[Docket No. **FAA-2023-0672**; Project Identifier **AD-2022-01429-T**; Amendment **39-22470**; AD **2023-12-12**]

#### Airworthiness Directives; The Boeing Company Airplanes

**ACTION:** Final rule.

Figure 1 to paragraph (g)(2)(i)—*Fundamental Effective Isotropic PSD at Outside Interface of Aircraft Antenna*

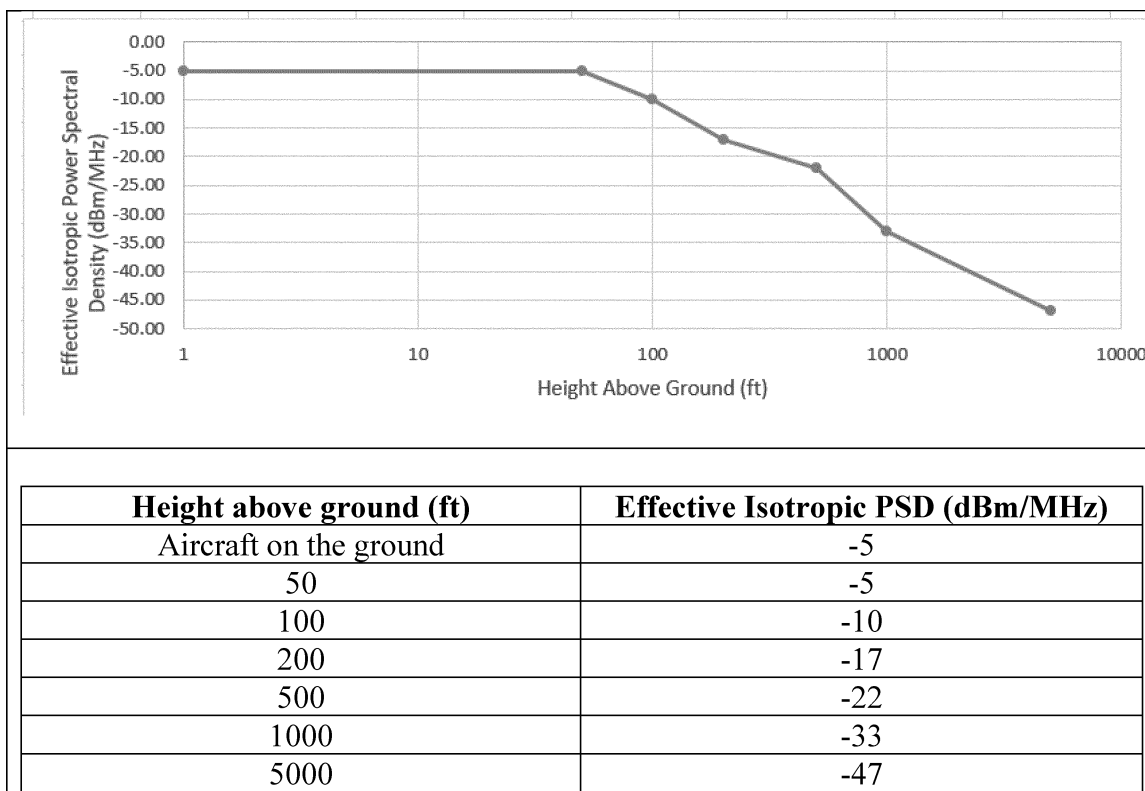
(i) Tolerance to radio altimeter interference, for the fundamental emissions (3.7–3.98 GHz), at or above the power spectral density (PSD) curve threshold specified in figure 1 to paragraph (g)(2)(i) of this AD.

Figure 2 to paragraph (g)(2)(ii)—*Spurious Effective Isotropic PSD at Outside Interface of Aircraft Antenna*

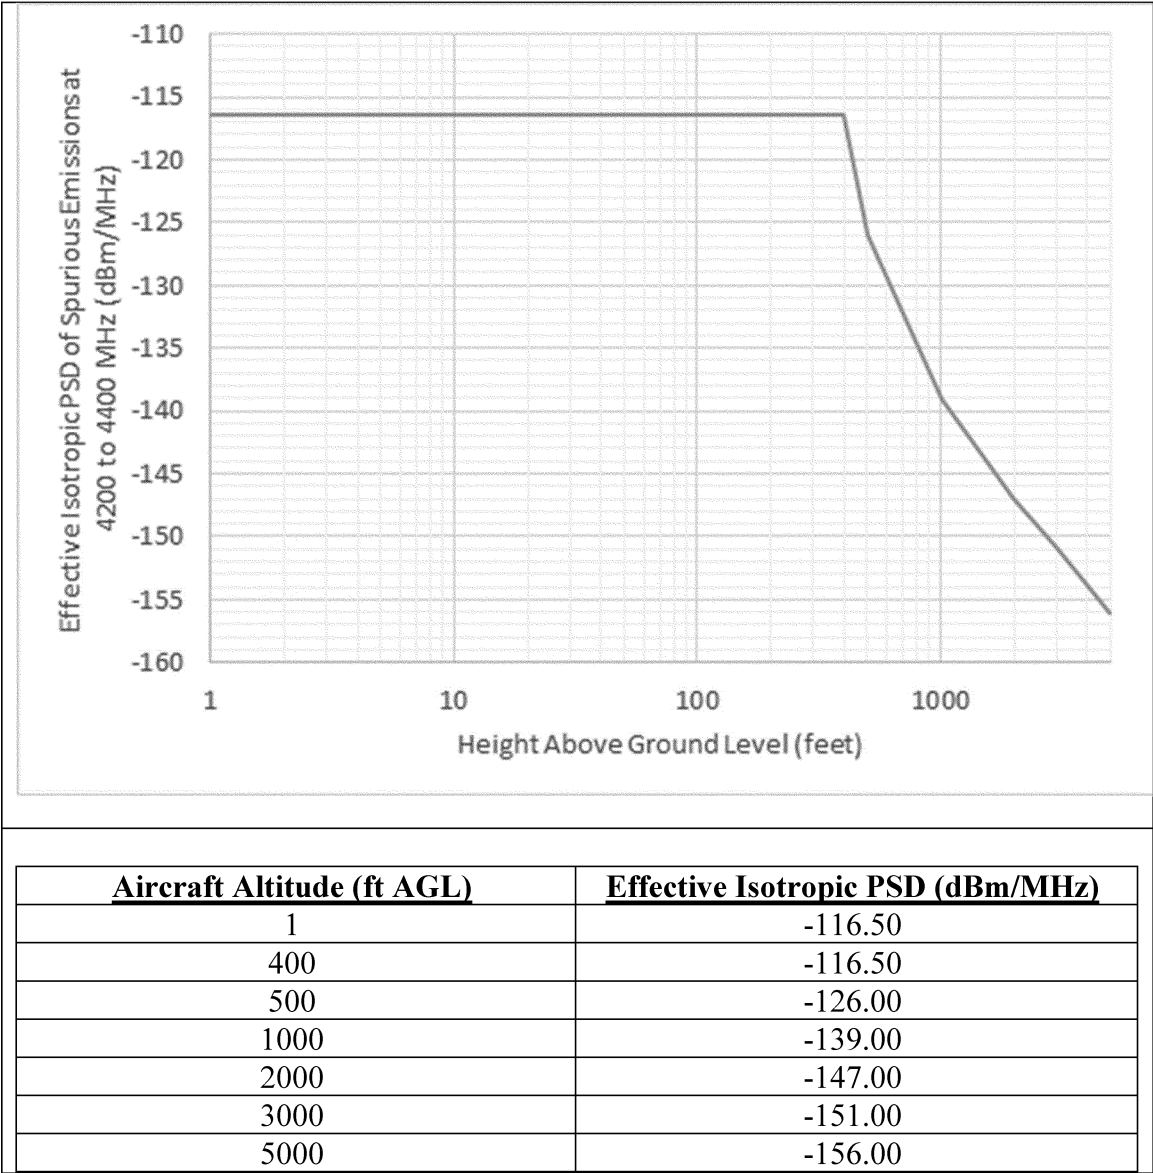
(ii) Tolerance to radio altimeter interference, for the spurious emissions (3.7–

3.98 GHz), at or above the PSD curve

threshold specified in figure 2 to paragraph (g)(2)(ii) of this AD.
